LIVERPOOL RANGE WIND FARM

Amendment Report

Report No. 23141/R02

Date: August 2023

Figure 3.8 Comparison between Approved Project Turbine Layout and RTS Project Turbine Layout

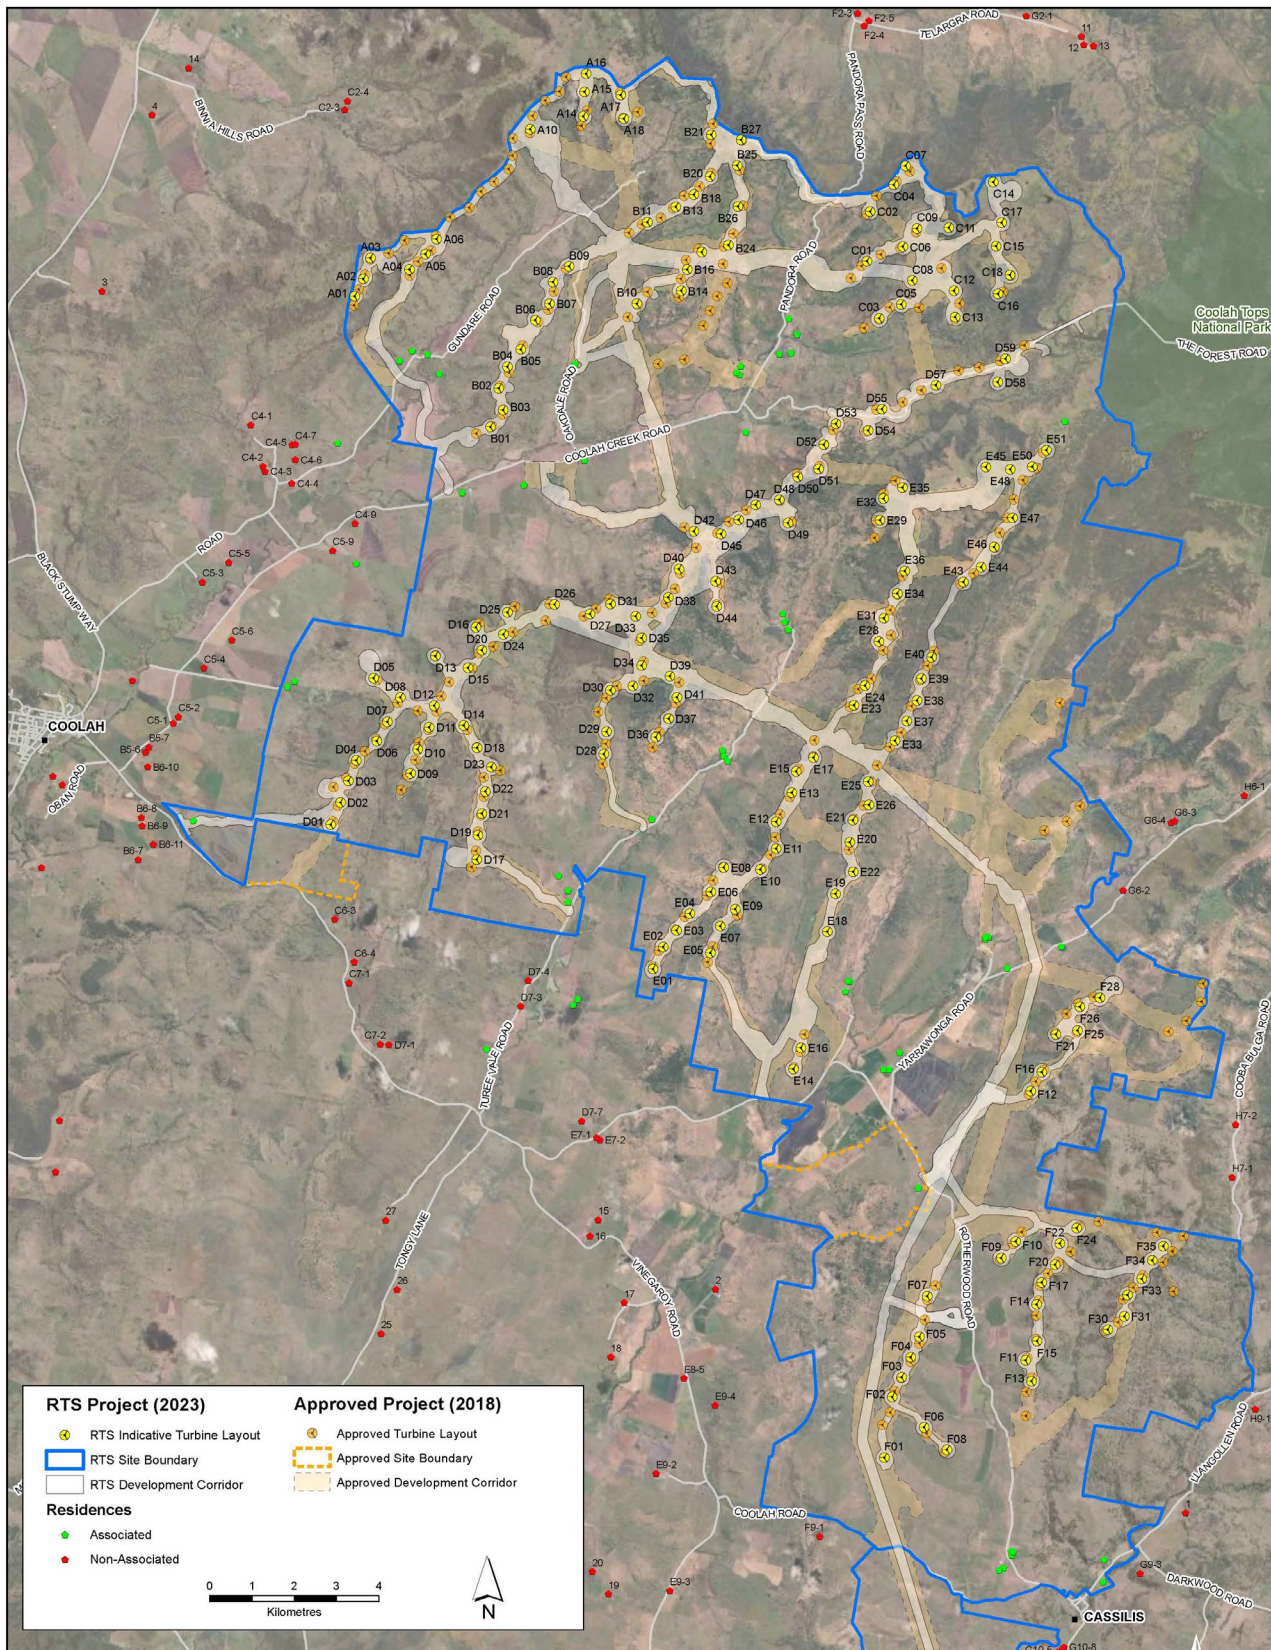
The EP&A Act requires that the application to modify the Development Consent be assessed in light of the nature and extent of the changes proposed to the Approved Project as part of the modification application. This section provides a comparison of the changes proposed to the Approved Project by the updated RTS Project the subject of the modification application. The changes for each of the key Project elements from the Approved Project to the RTS Project are presented in **Table 3.3**. Changes to the turbine layout and other key ancillary infrastructure from the Approved Project to the RTS Project are presented in **Figure 3.8**, **Figure 3.9**, and **Figure 3.10** respectively.

Project Element	Approved Project (2018)	RTS Project (2023)	Change from Approved Project to RTS Project
Site boundary and development corridor			
Site boundary area	51,336 ha	51,389 ha comprised of: <ul style="list-style-type: none"> • 46,532 ha (wind farm) • 4,857 ha (external transmission line). 	Increase by 53 ha (-0.1%)
Development corridor	12,405 ha	8,718.2 ha comprised of: <ul style="list-style-type: none"> • 7,322.3 ha (wind farm) • 1,540.5 ha (external transmission line). 	Decrease by 3,686.8 ha (-30%)
Turbine parameters and wind farm layout			
Maximum Number of turbines	267	185	Decrease by 82 (-31%)
Maximum blade tip height (AGL)	165 m	215 m	Increase by 50 m (+30%)
Indicative hub height	100 m	129 m	Increase by 29 m (+29%)

Project Element	Approved Project (2018)	RTS Project (2023)	Change from Approved Project to RTS Project
Indicative rotor diameter	130 m	172 m	Increase by 42 m (+32%)
Indicative minimum blade ground clearance	35 m	40 m	Increase by 5 m (+14%)
Indicative rotor swept area (RSA) per turbine	13,273 m ²	23,235 m ²	Increase by 9,962 m ² (+75%)
Indicative total RSA for wind farm	3,543,891 m ²	4,298,475 m ²	Increase by 754,584 m ² (+21%)
Total generating capacity	961 MW (based on 3.6 MW turbine)	1,332 MW (based on 7.2 MW turbine)	Increased by 371 MW (+39%)
Ancillary infrastructure			
Wind farm access track length	256.5 km	246.4 km	Decrease by 10.1 km (-4%)
Internal transmission line length	28.19 km	41.7 km	Increase by 13.51 km (+48%)
Reticulation cabling length	Underground: 274.1 km Overhead line: 46.7 km	Underground: 173.5 km	Decrease by 100.6 km (-37%)
Permanent PCV met masts	Up to 10	Up to 10	No change
Collector substations	Up to 4	Up to 7	Increase by 3

Figure 3.9 Comparison between Approved Project and RTS Project Ancillary Infrastructure (northern section)

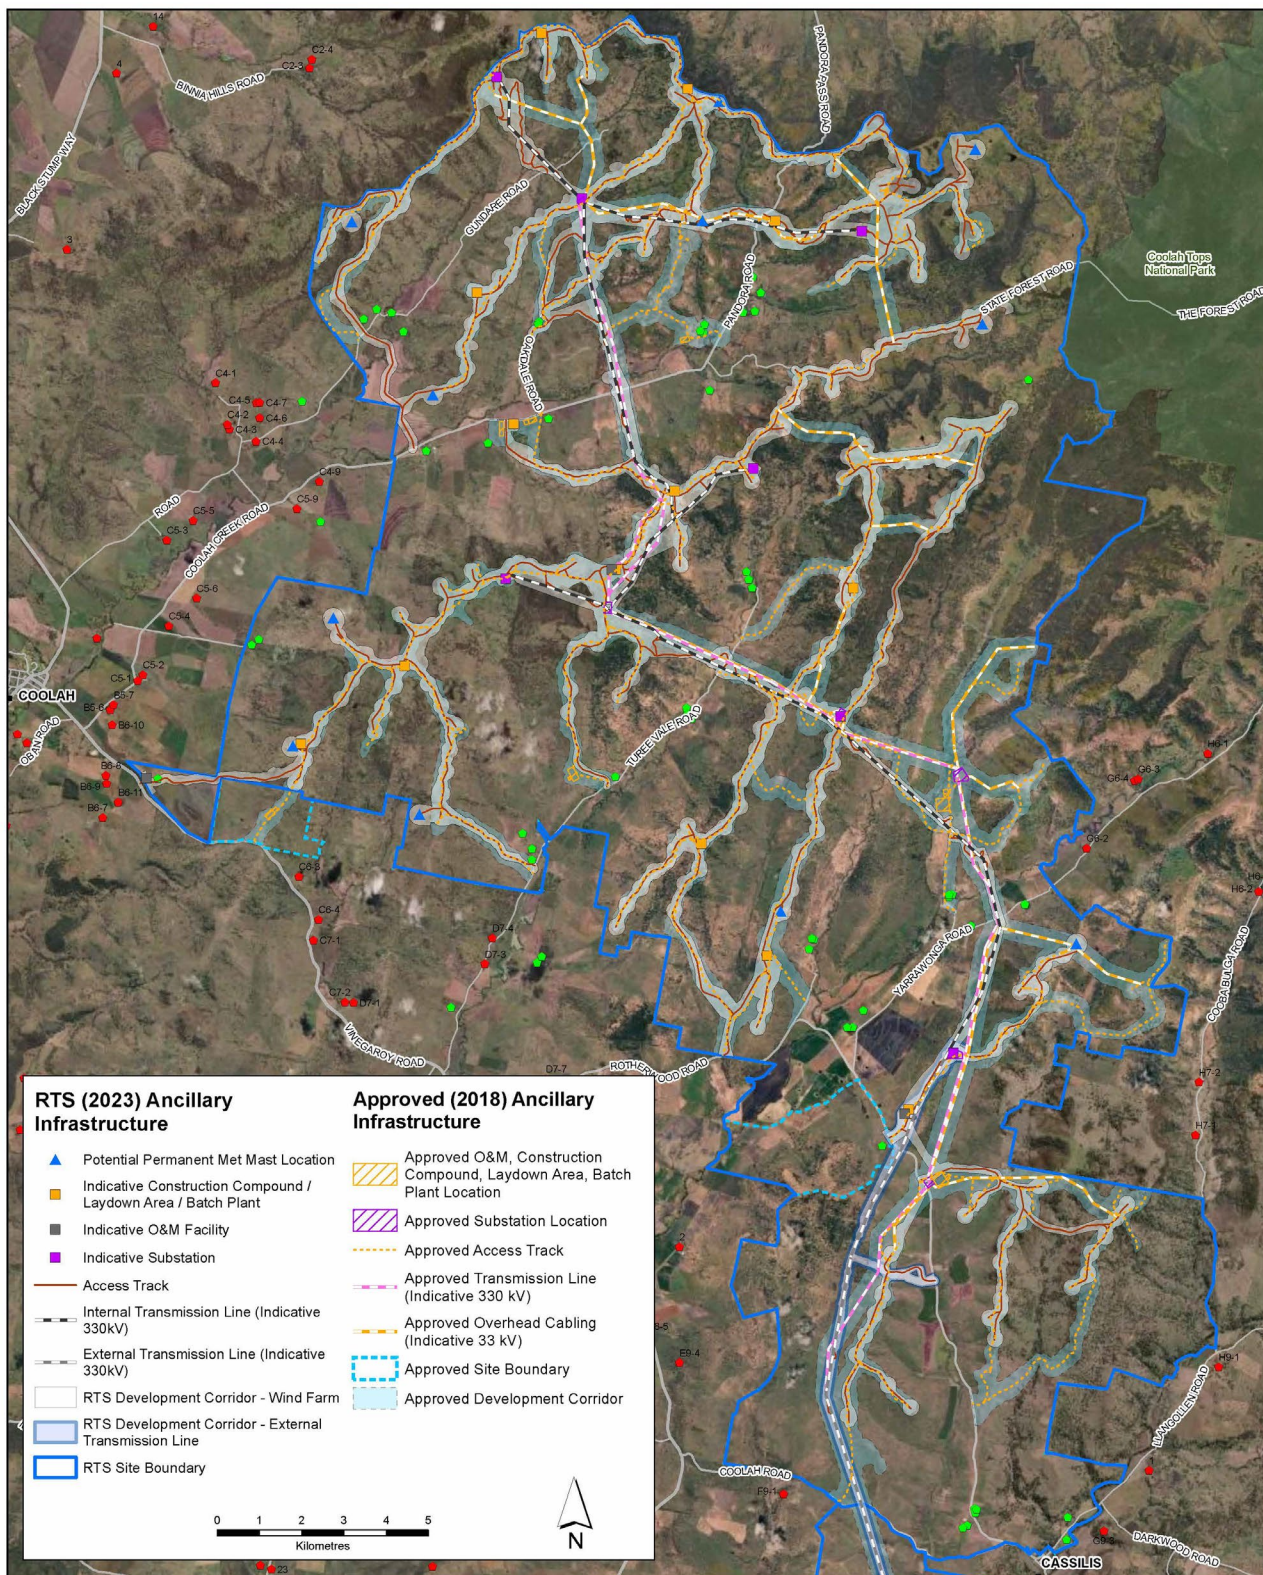
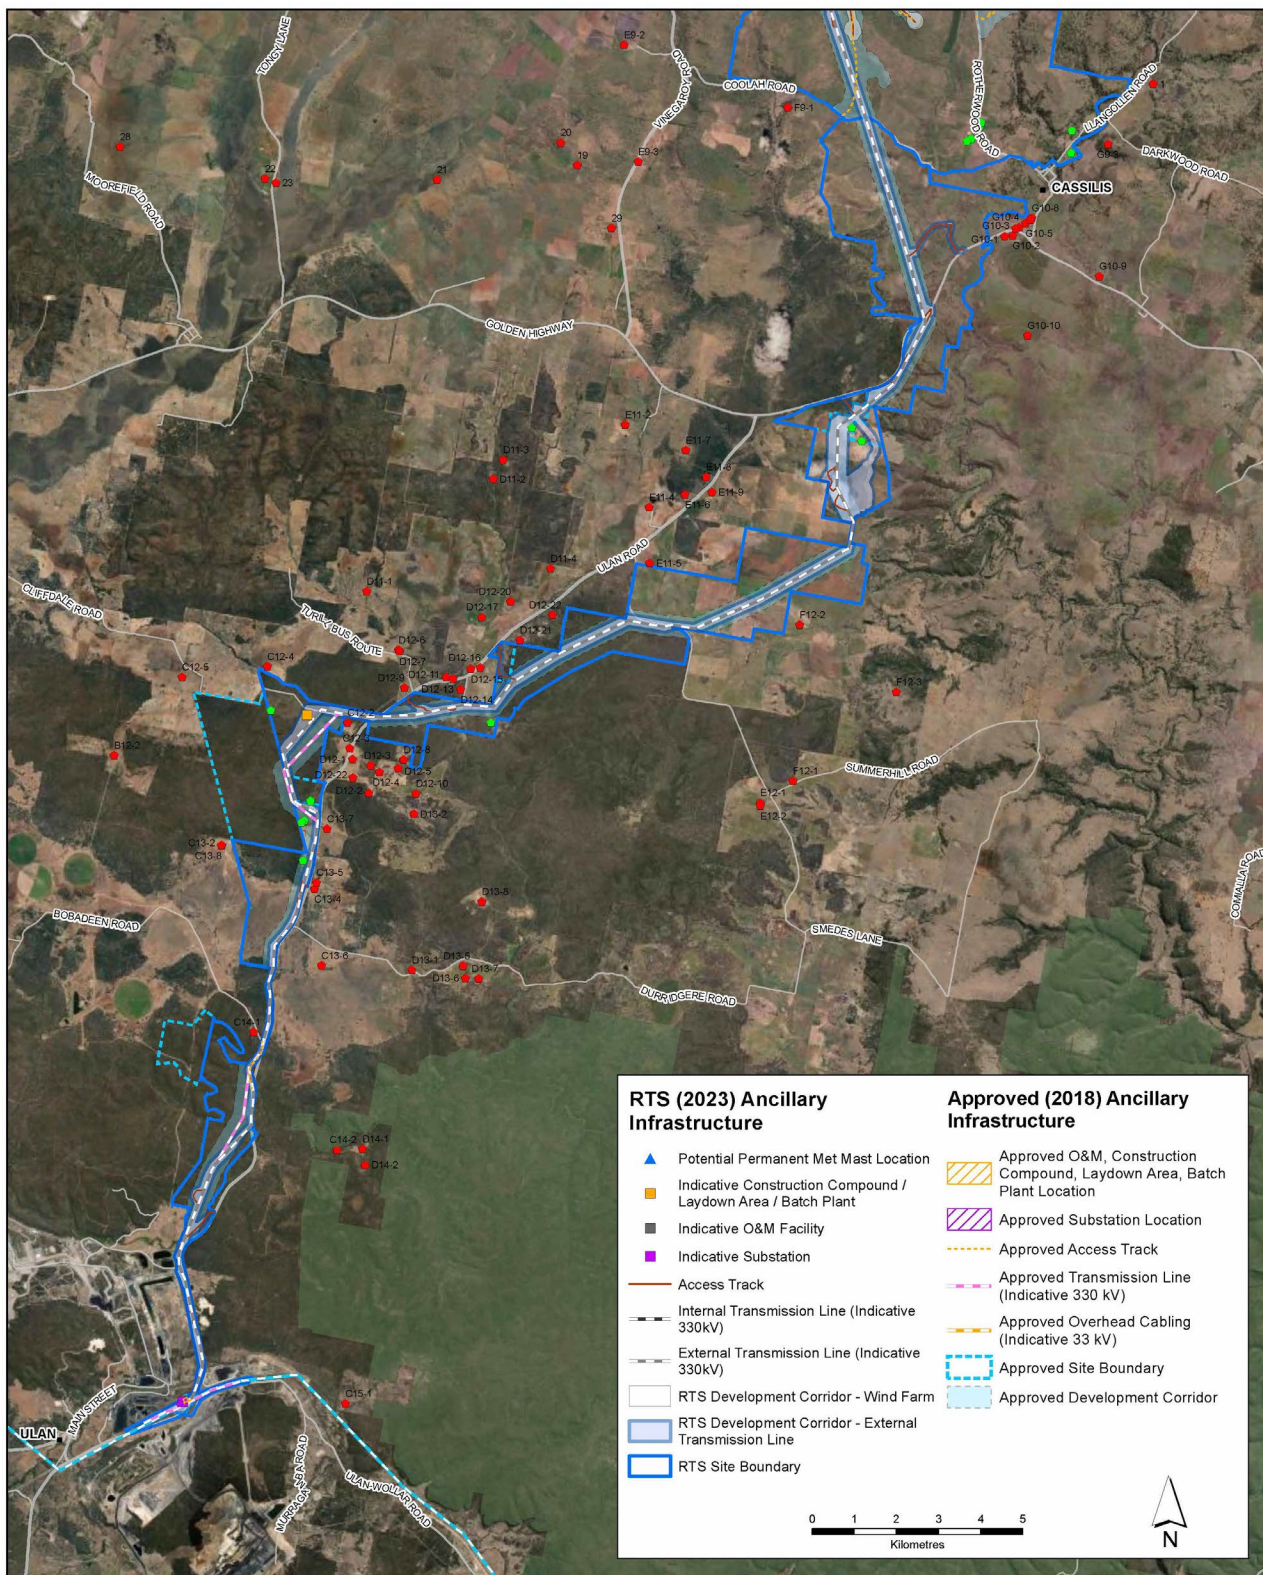
O&M facilities	1	Up to 3	Increase by 2
Temporary site calibration met masts	Not specified	Up to 10	-
Temporary concrete batch plants	Up to 4	Up to 9	Increase by 5
Temporary construction compound/laydown areas	Up to 6	Up to 9	Increase by 3
External transmission line and connection infrastructure			
External transmission line length	56.82 km	54.6 km	Decreased by 2.2 km (-4%)
Access track length	56.8 (based on mapping from original EIS)	57.8 km	Increased by 1 km (+2%)
Temporary concrete batch plants	Up to 1 (Ulan connection point)	Up to 1 (off Cliffdale Road, Turill)	No change
Temporary construction compound/laydown areas	Up to 1 (Ulan connection point)	Up to 1 (off Cliffdale Road, Turill)	No change
Connection substation/switchyard	Up to 1	Up to 1	No change
